NISSAN DIESEL AMERICA, INC.

RECALL BULLETIN O3V-224

**VOLUNTARY SAFETY RECALL CAMPAIGN NUMBER O3V-224:
 INSPECT AND REPLACE PASSENGER SEAT BELT ANCHOR ON
 2002 ~ 2004 MODEL YEAR UD1200/UDI400/UDI800CS VEHICLES**

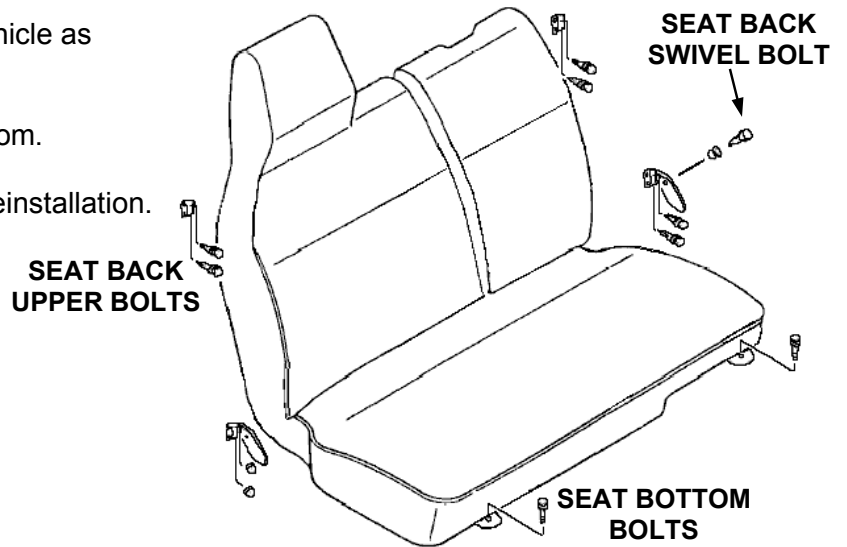
- Check the passenger seat belt anchor from the back of the cab.
 - If the anchor resembles the photo on the left, no further action is necessary. Proceed to Step 9 on Page 5 of this bulletin.
 - If the anchor resembles the photo on the right, the passenger seat frame must be replaced. Proceed immediately with the instructions on the following page.

NOT NECESSARY TO REPLACE SEAT FRAME

OUTSIDE LOWER THAN INSIDE

SEAT BELT ANCHOR BOLT OUTBOARD

SEAT FRAME MUST BE REPLACED

INSIDE LOWER THAN OUTSIDE

SEAT BELT ANCHOR BOLT IN THE MIDDLE

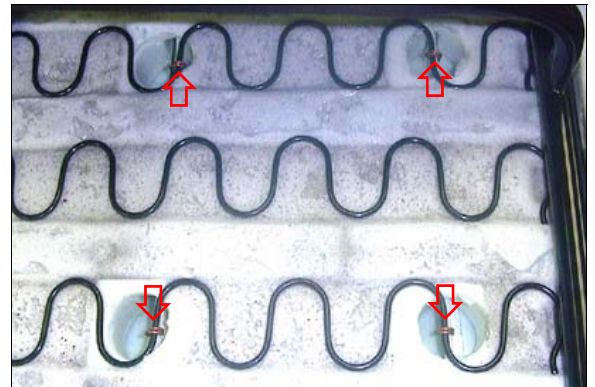
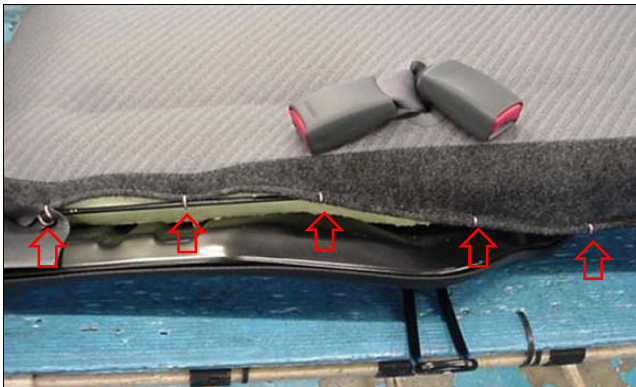
1. Remove the passenger seat from the vehicle as shown.

- Separate the seat back from the seat bottom.
- Save the seat back and all fasteners for reinstallation.
